Item: Taco Bell/Wendy's Development - Northeast Corner of Golf Rd. & Arlington Heights Rd. - T1605

VILLAGE OF ARLINGTON HEIGHTS **STAFF DEVELOPMENT** **COMMITTEE REPORT**

Temp File Number: T1605

Project Title: Taco Bell & Wendy's PUD/SUP

OVERALL LANDSCAPE PLAN

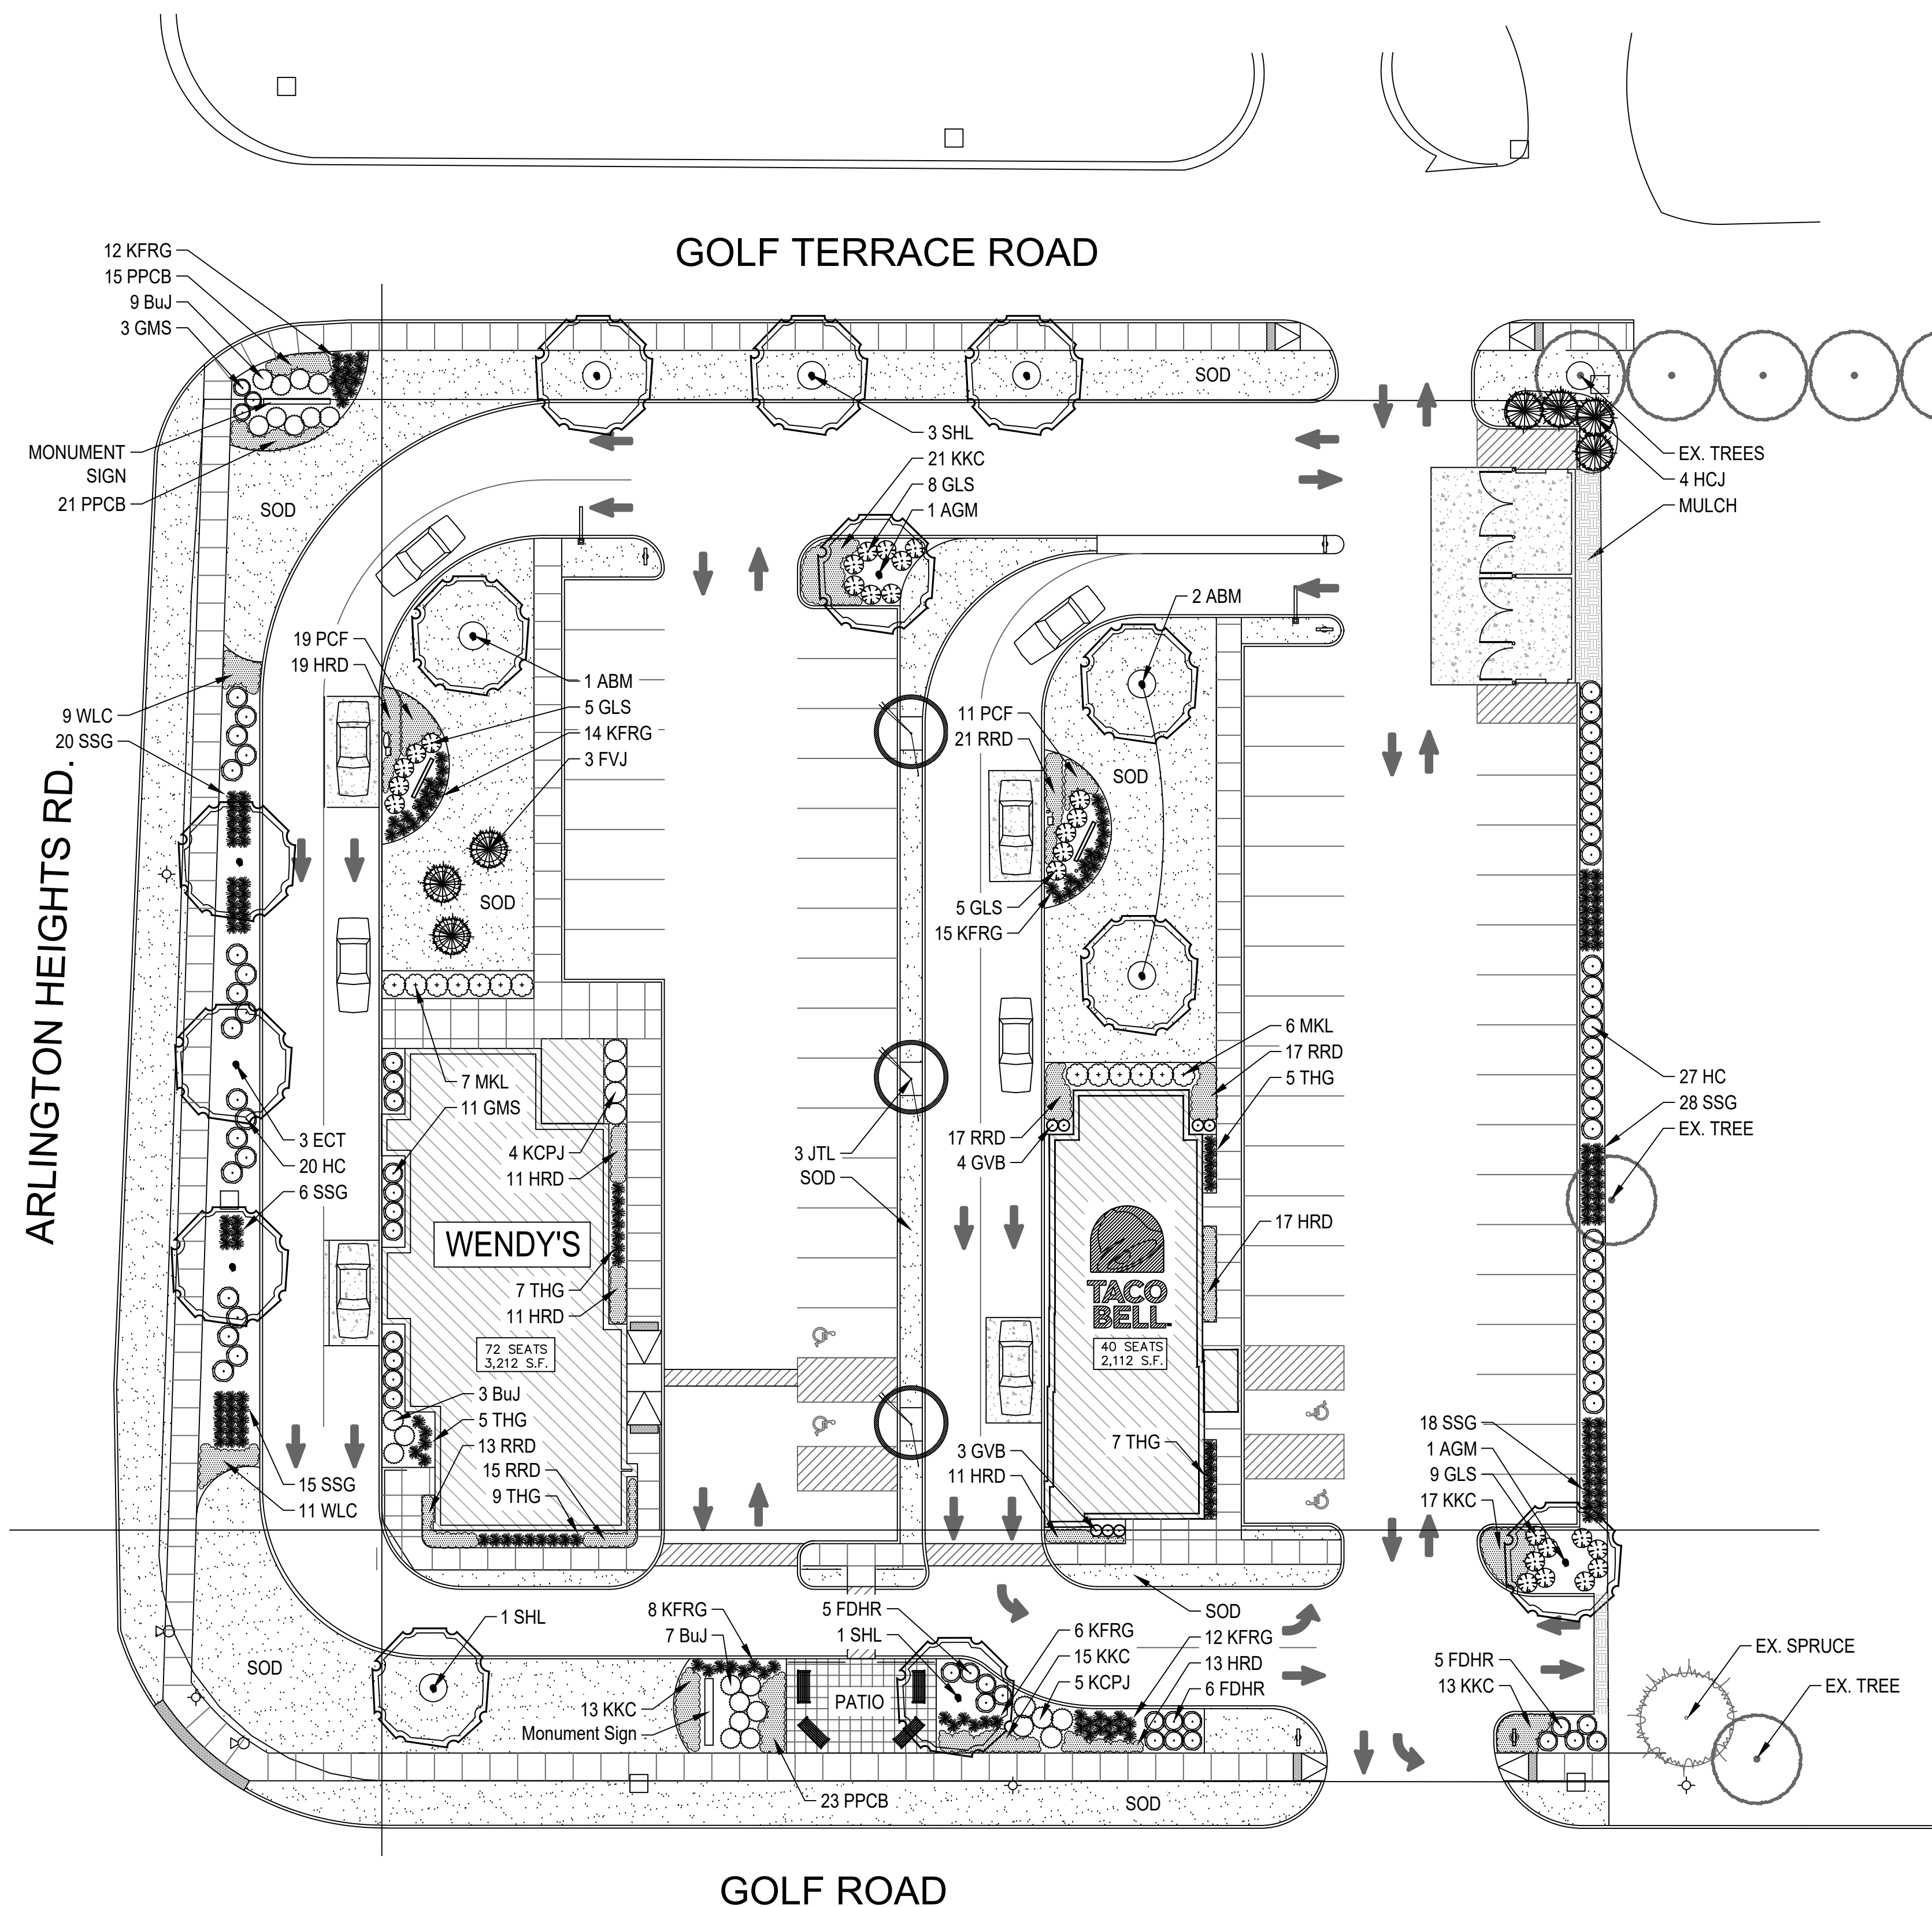
Given the orientation of the site, which places the drive-thru lane for Wendy’s along Arlington Heights Road, extensive landscape plantings are needed to buffer the appearance of the drive-thru lane. A preliminary

landscape plan has been provided, however, enhancements to the landscaping along the Arlington Heights Road are needed. The petitioner should provide additional plantings in this area and staff recommends the petitioner explore the possibility of a decorative wrought-iron style fence in this location as well.

2. The petitioner shall incorporate a unique focal feature at the corner of Golf Road and Arlington Heights Road.
3. The landscape plan shall be revised to incorporate a robust program of landscape plantings along Arlington Heights Road and Golf Road to screen the proposed drive-thru lanes.
